Transmitted by the expert from Japan (60th GRE, 1 - 3 October 2008
agenda item 10(d))

Proposed amendments to Regulation No.53

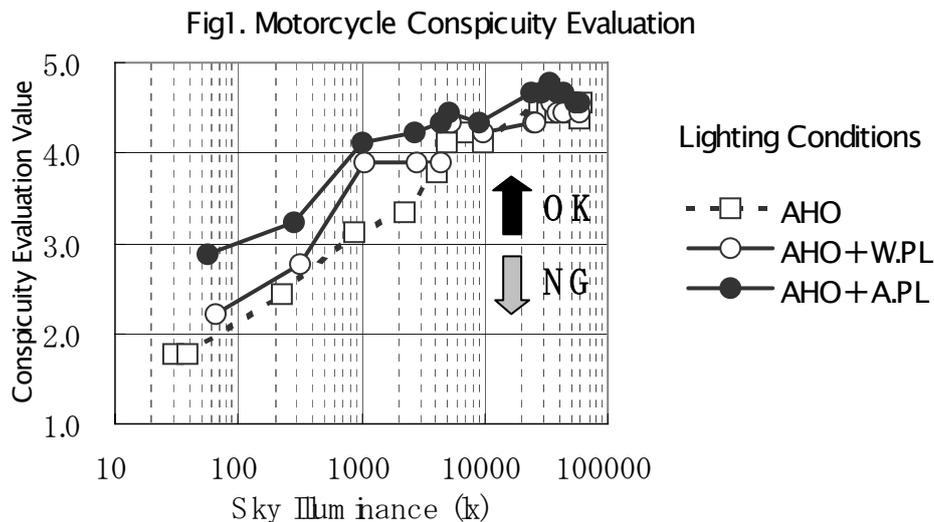
The results of the conspicuity evaluation for motorcycles followed by four-wheeled vehicles with DRL on (Fig. 1) indicate higher motorcycle conspicuity evaluation values for the lighting condition of AHO + white position lamp than that of AHO only, and these values are even higher for AHO + amber position lamp. The effect of the amber position lamp on the improvement of conspicuity is especially prominent under conditions where sky illuminance is low (about 5,000 lm or below). (For details, see “GRE-60-23.”)

Fig. 2 Motorcycle Conspicuity Evaluation

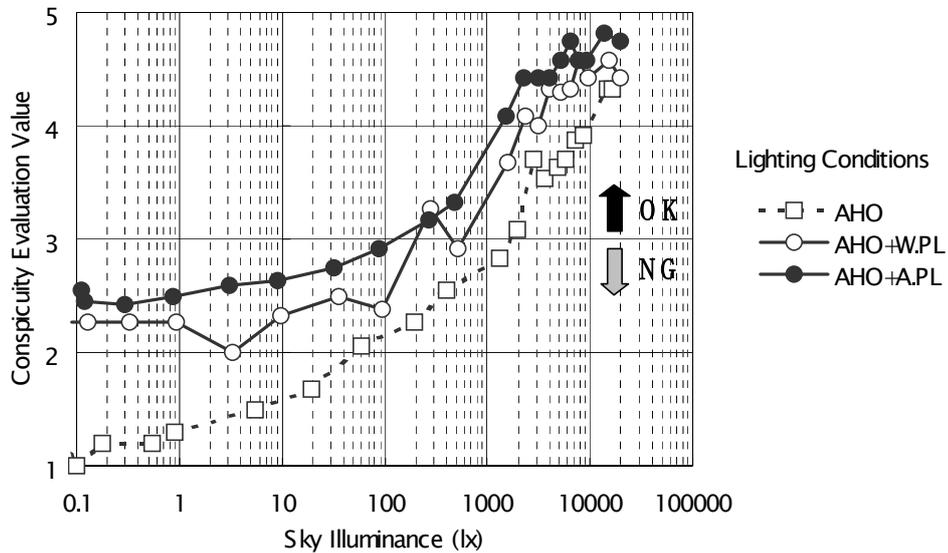
Furthermore, in the case of night driving where four-wheeled vehicles use the passing beam instead of DRL when following motorcycles, the results of the conspicuity evaluation for those motorcycles (Fig. 2) also show higher conspicuity evaluation values for the lighting condition of AHO + white position lamp than that of AHO only, and these values are even higher for AHO + amber position lamp. (For details, see “GRE-60-24.”)
